**Report: TAB REPORT**  
**Function: Test, Adjust, & Balance**  
**Date: 04/05/2023**

**03-27-23 FREDDY'S - JASPER, AL**

Project: 03-27-23 FREDDY'S - JASPER, AL

KEF2Conduit.jpeg

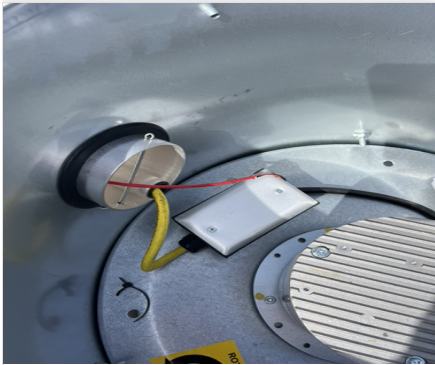
**Issue Name :** KEF2 wire is not ran through conduit

**Description :** Recommended to install conduit.

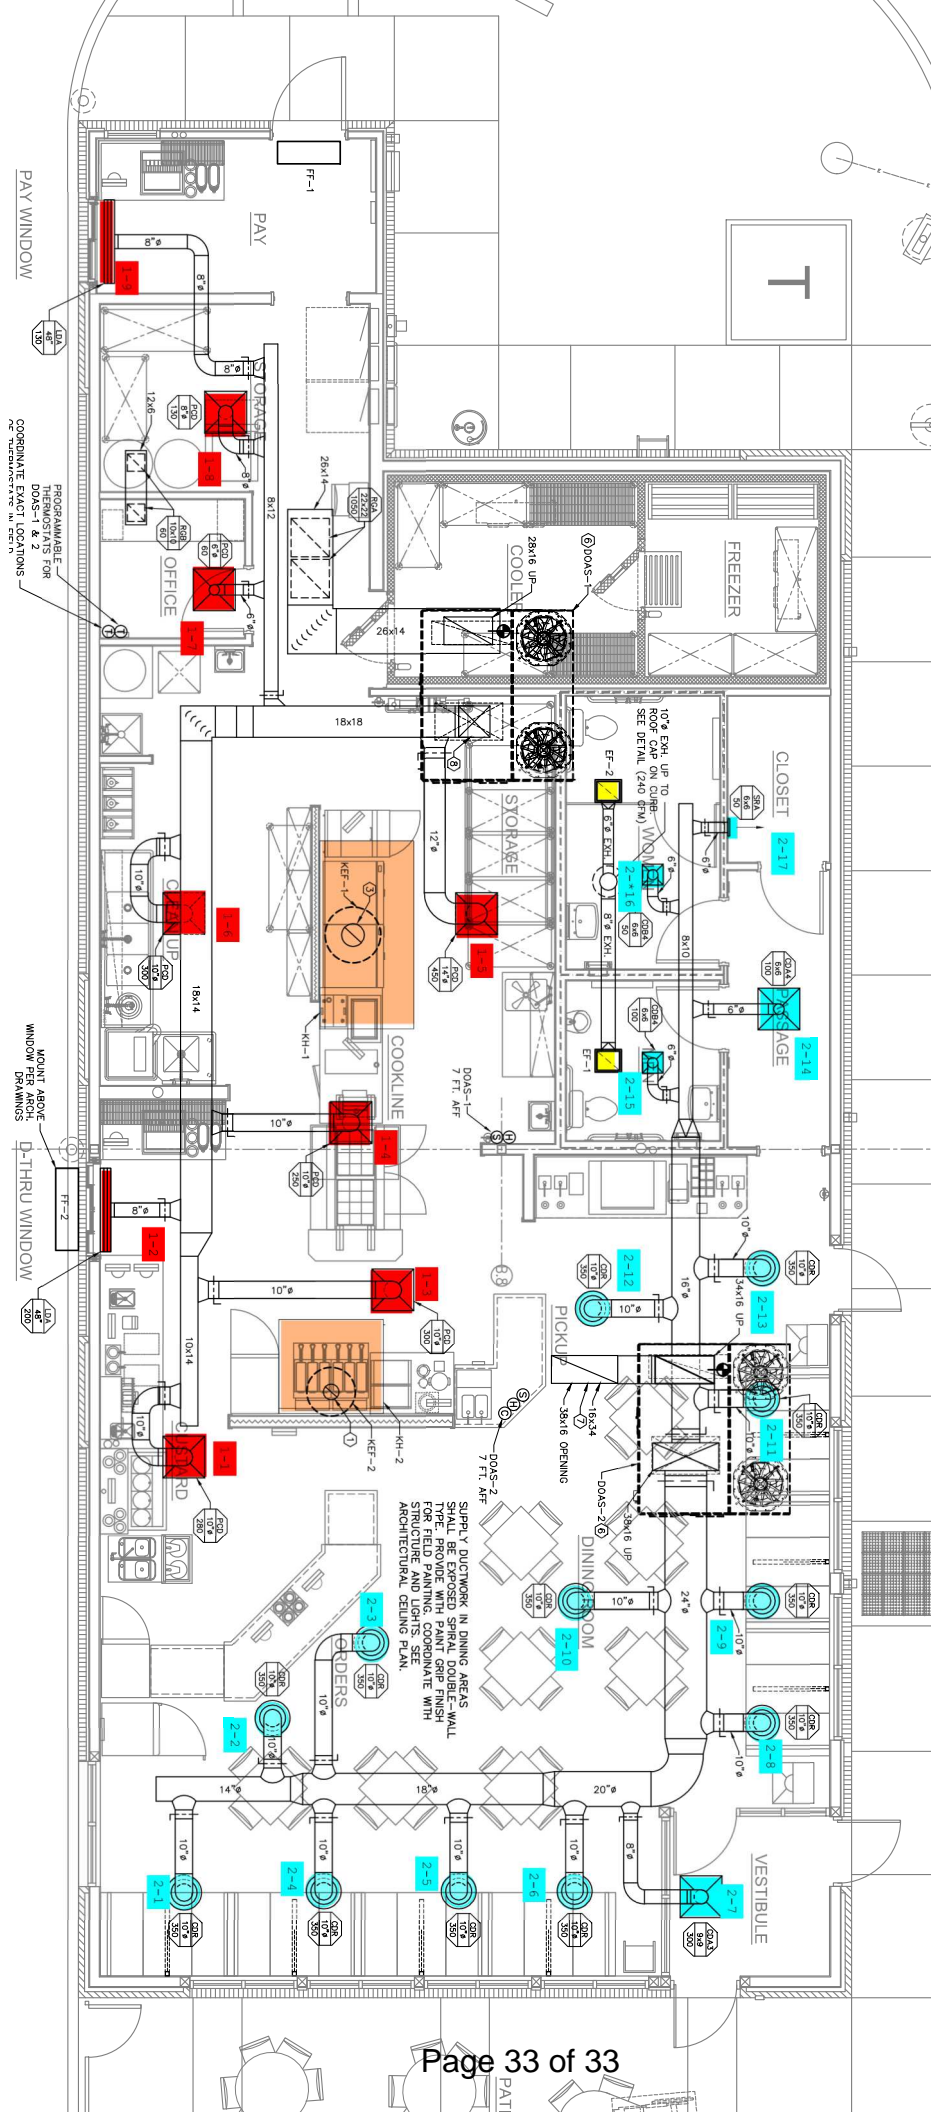
Notes: Diffuser balance incomplete due to excessive leakage in ductwork.
